RESERVE @ MITCHELL MILL

CONSTRUCTION PLANS

TOWN OF ROLESVILLE, WAKE COUNTY, NORTH CAROLINA

CONSTRUCTION INFRASTRUCTURE DRAWINGS
CID-24-04

OVERALL GRADING AND DRAINAGE PLAN

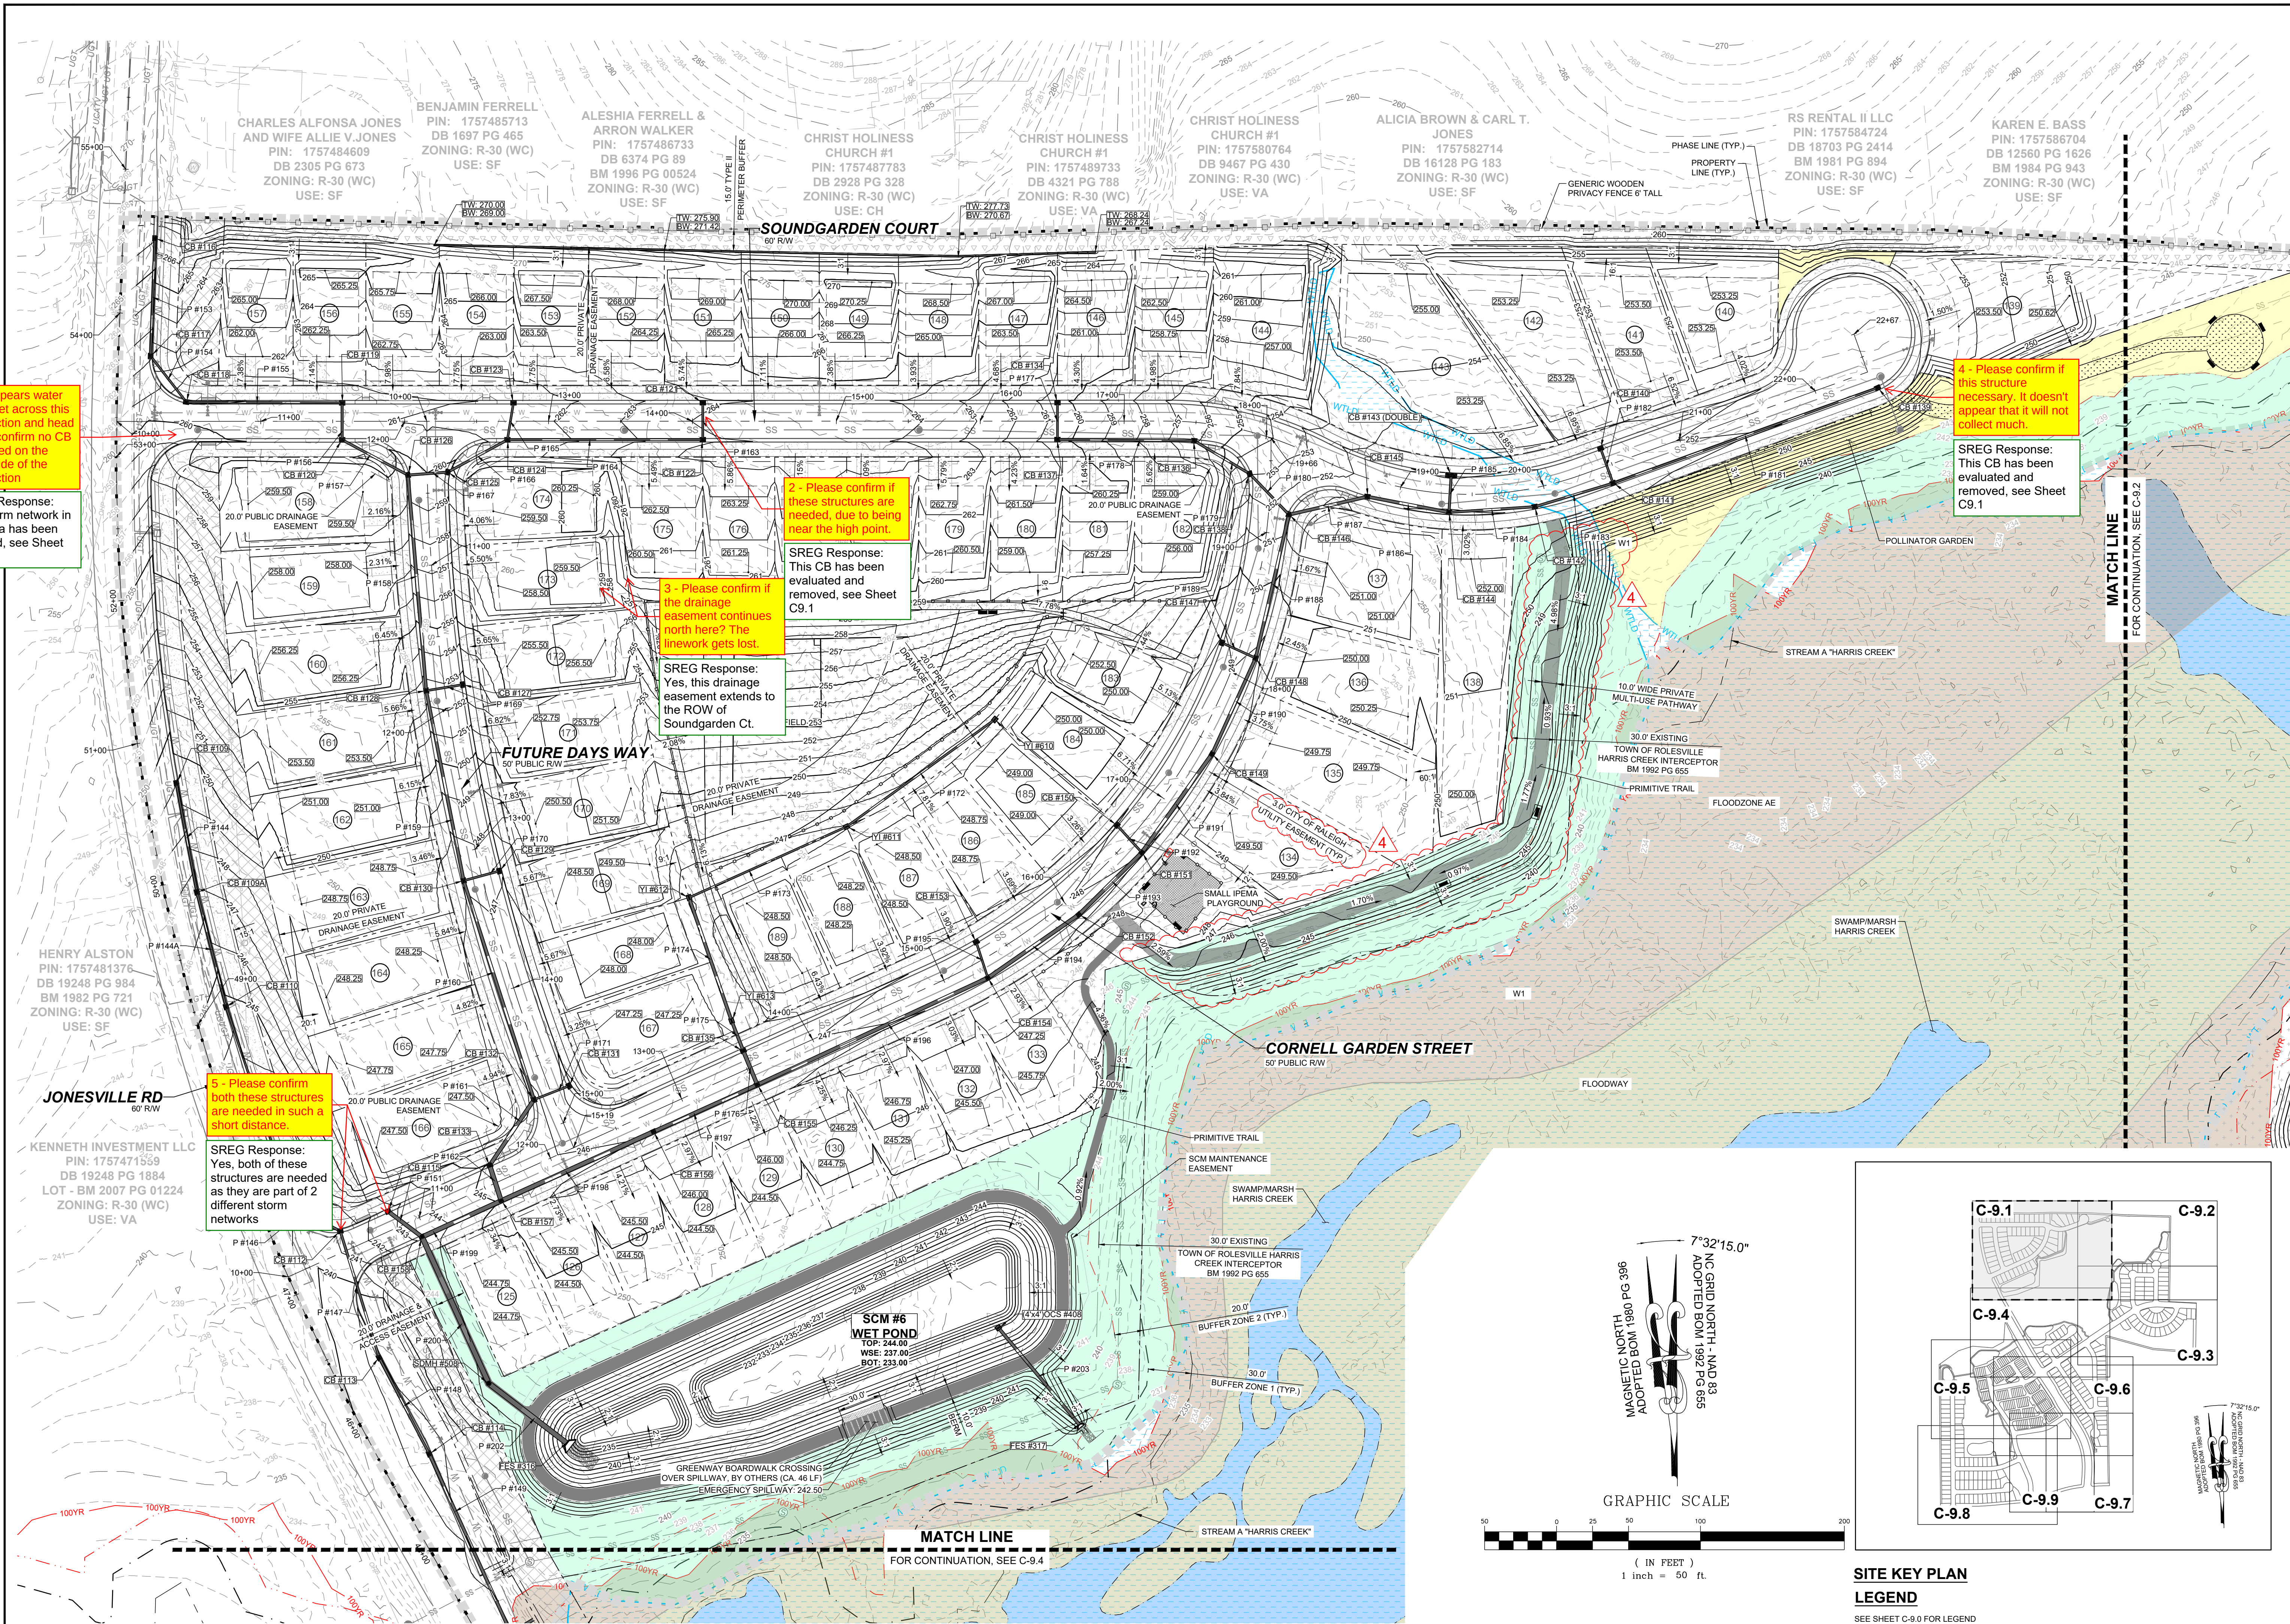
1 - It appears water will sheet across this intersection and head south; confirm no CB is needed on the south side of the intersection

3 - Please confirm if the drainage easement continues north here? The linework gets lost.

4 - Please confirm if this structure necessary. It doesn't appear that it will not collect much.

SREG Response: The storm network in this area has been updated, see Sheet C9.1

SREG Response: This CB has been evaluated and removed, see Sheet C9.1

SREG Response: Yes, this drainage easement extends to the ROW of Soundgarden Ct.

SREG Response: This CB has been evaluated and removed, see Sheet C9.1

SREG Response: Yes, both of these structures are needed as they are part of 2 different storm networks
